25W Mobile Transceiver Updated Instruction

6. Alias Setting method:

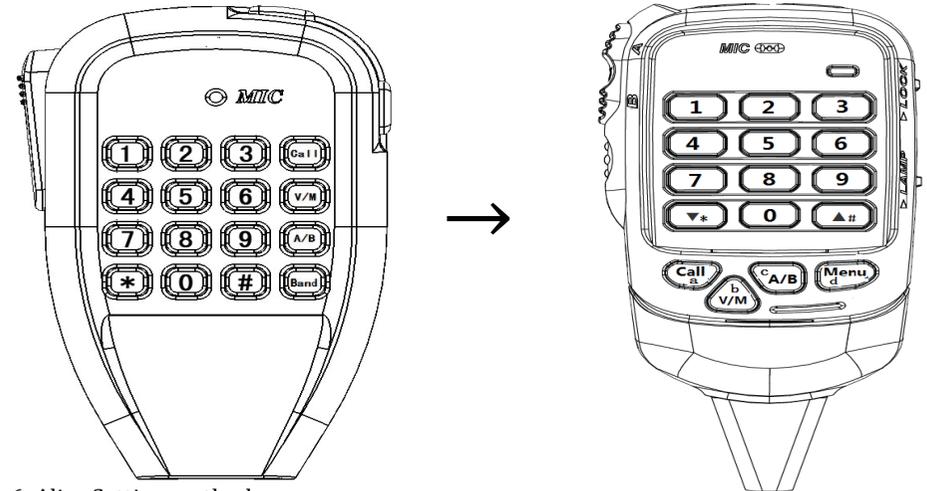
- a. Using the front panel of the radio: Enter menu 22, press P2 to access modification, press P3 to confirm modify, press P3 to backspace, press M to exit without modification.
- b. Using the microphone: Press "Menu+2+2" to enter menu 22, press "Call (A)" key to confirm modify, press "V/M (B)" to access modification, press "A / B (C)" to backspace, press "Menu (D)" key to exit without modification.
